**39TH AND ADELINE MIXED-USE PROJECT
ENVIRONMENTAL IMPACT REPORT
RESPONSE TO COMMENTS DOCUMENT**

STATE CLEARINGHOUSE # 2007092005

November 2008

Section @ 39th St.
1. Pressure Brick facade.

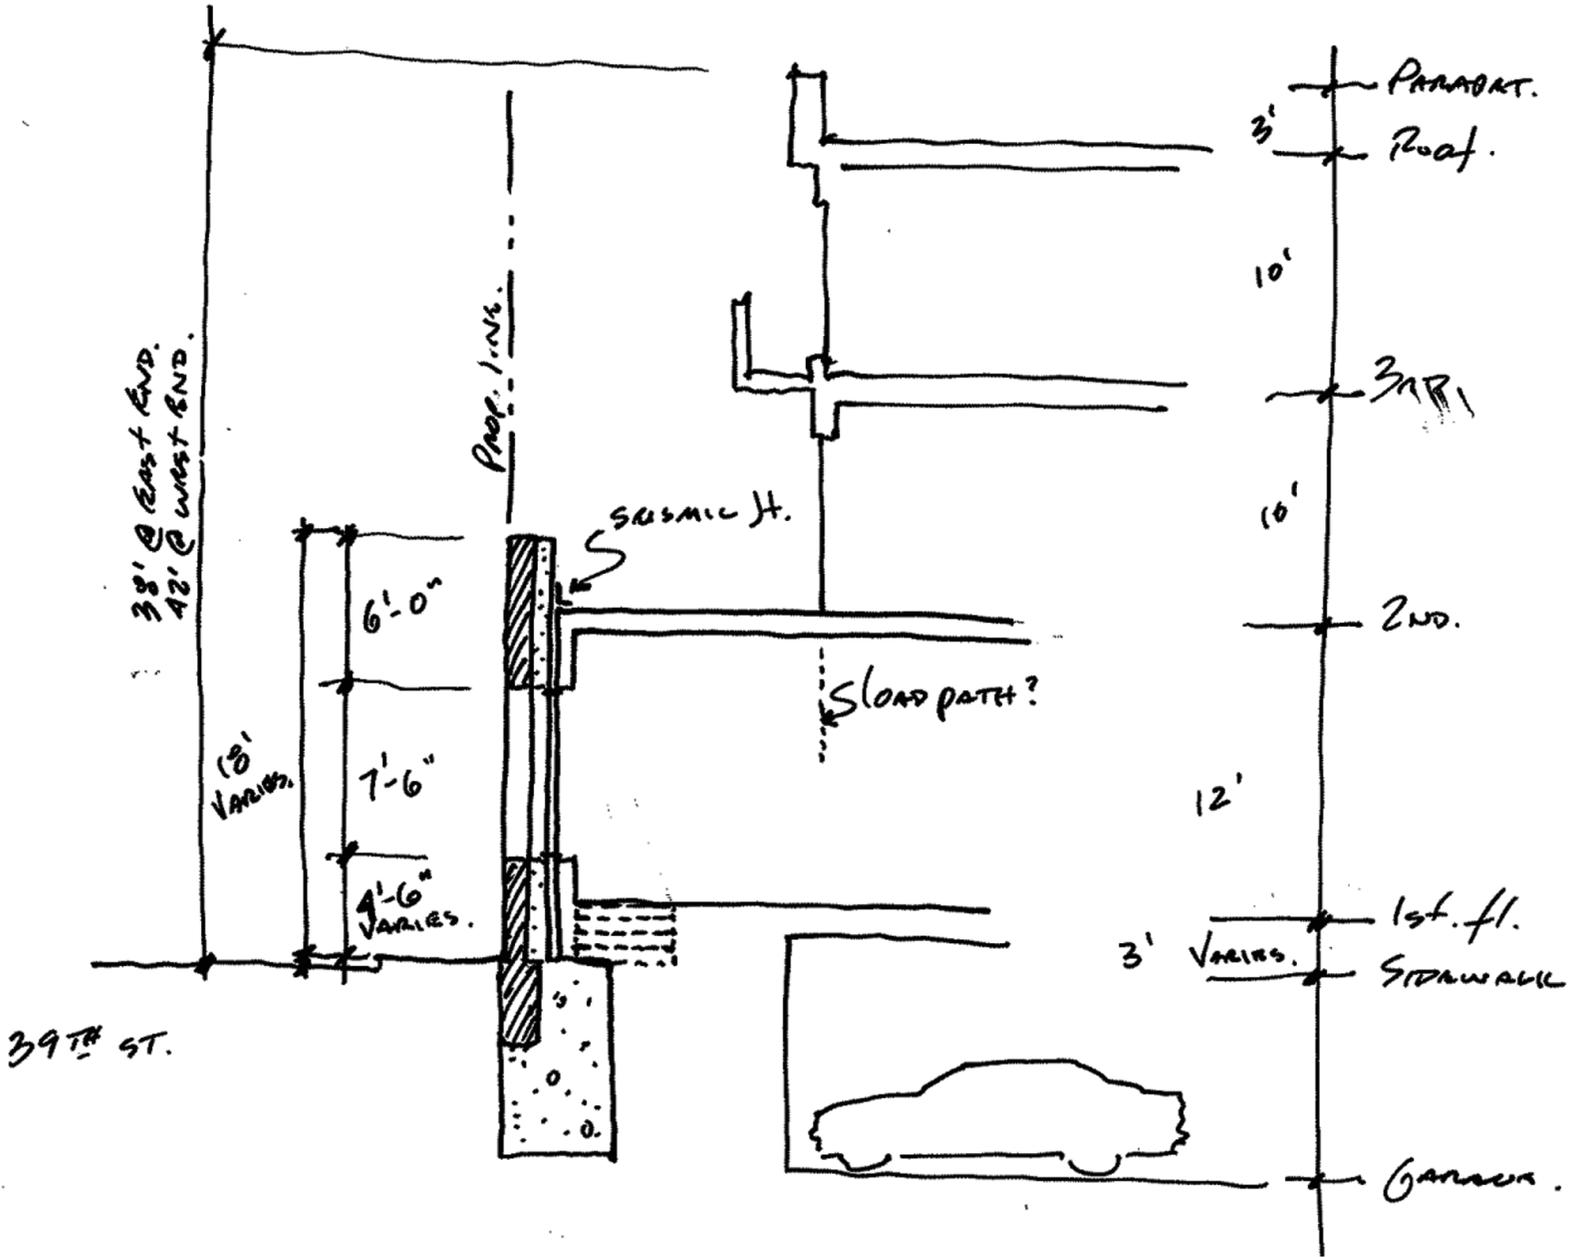
If it is absolutely essential to preserve the brick wall, and we recommend against this, it would have to first be repaired and stabilized. Then it could possibly be reinforced with a 4 to 6 inch thick layer of shotcrete. The shotcrete would be placed over a two-way grid of reinforcing bars. In addition, there would need to be dowels at roughly 2'-0" on center each way to connect the existing brick to the new shotcrete. The foundation would also have to be rebuilt.

A new foundation for the composite brick-shotcrete wall will be difficult to construct because the foundation will need to be dug parallel to the existing foundation. The new foundation would have to be tied structurally to the existing foundation (the construction of which is unknown). As we understand a new basement for parking is to be constructed about 10-feet from the existing wall, this would be a difficult, potentially risky operation.

In summary, while restoring the wall is technically feasible, it could be done only at great expense and some risk to the workmen. We strongly recommend against it.

STABILIZED WALL PLAN

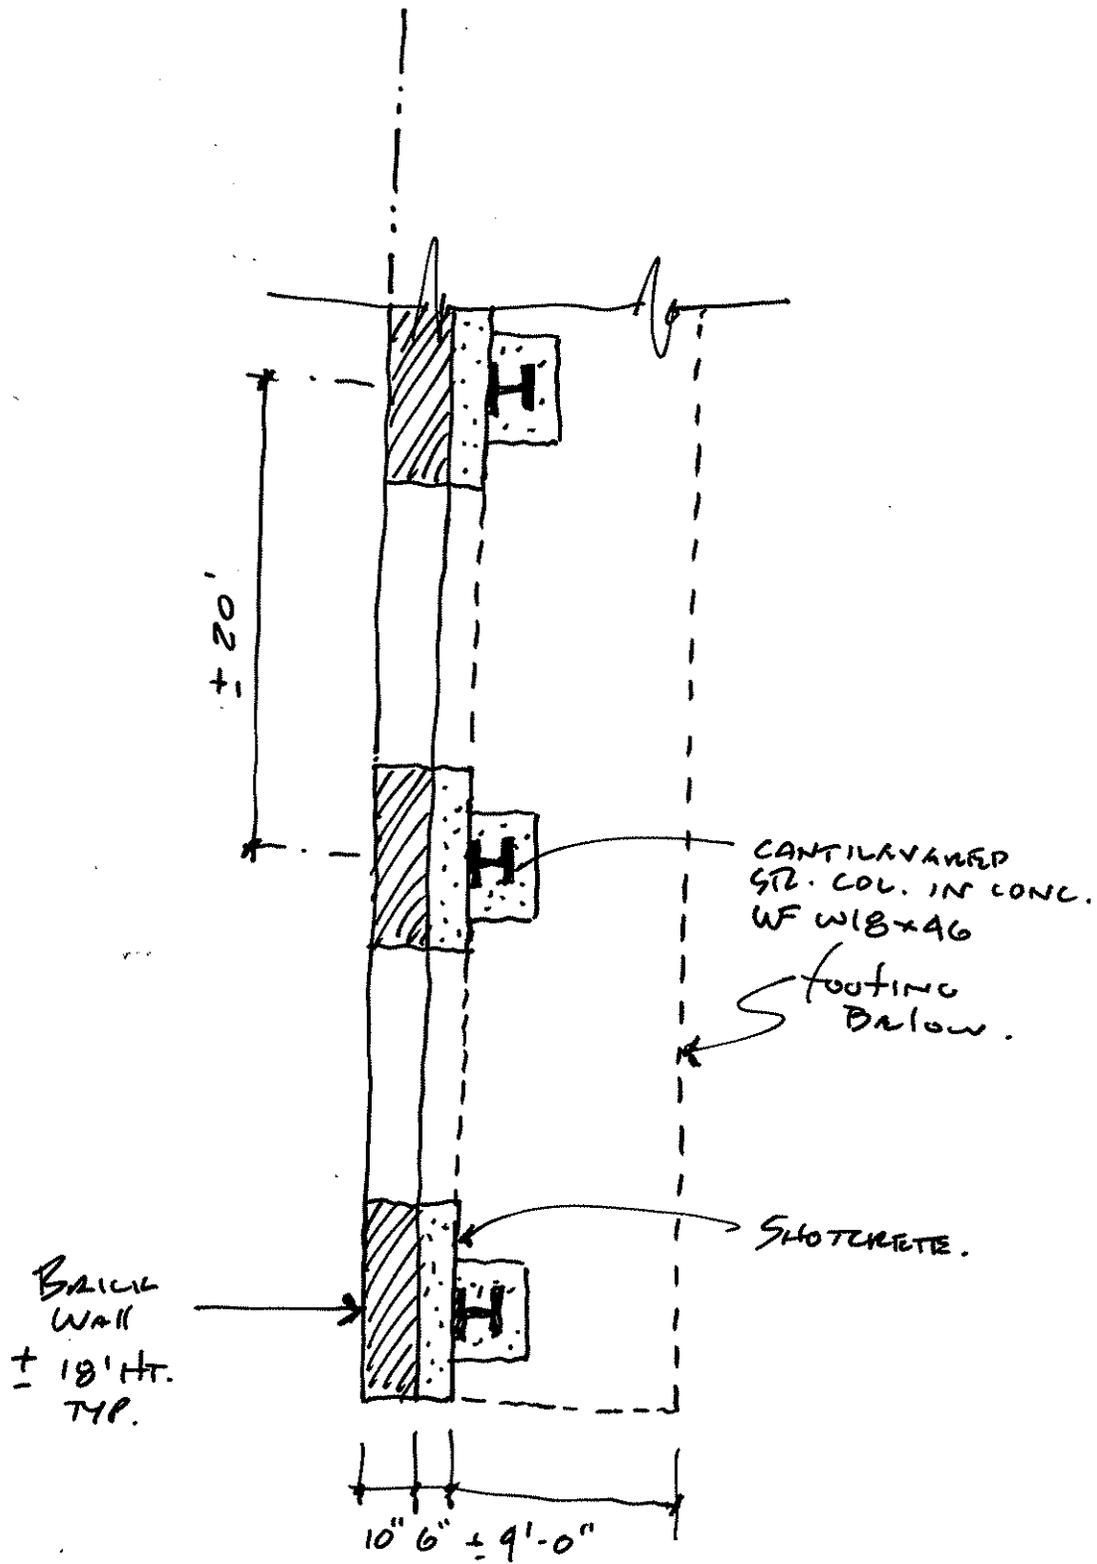
- Response G-3: Refer to the Master Response and Appendix A.
- Response G-4: Refer to the Master Response and Appendix A.
- Response G-5: The materials in Appendix A include conceptual building sections and a wall plan. The alternative would accommodate 90 residential units, as assumed in the Draft EIR. Refer to the Master Response and Appendix A for additional detail. Regarding the “pros and cons” of the alternative, refer to pages 124 and 128 of the Draft EIR for an analysis of the potential environmental benefits and impacts of the alternative. An evaluation of the pros and cons of the project as they relate to issues other than physical environmental impacts (e.g., economic feasibility) is outside the purview of CEQA, and structural considerations are addressed in the letter included as Appendix A.
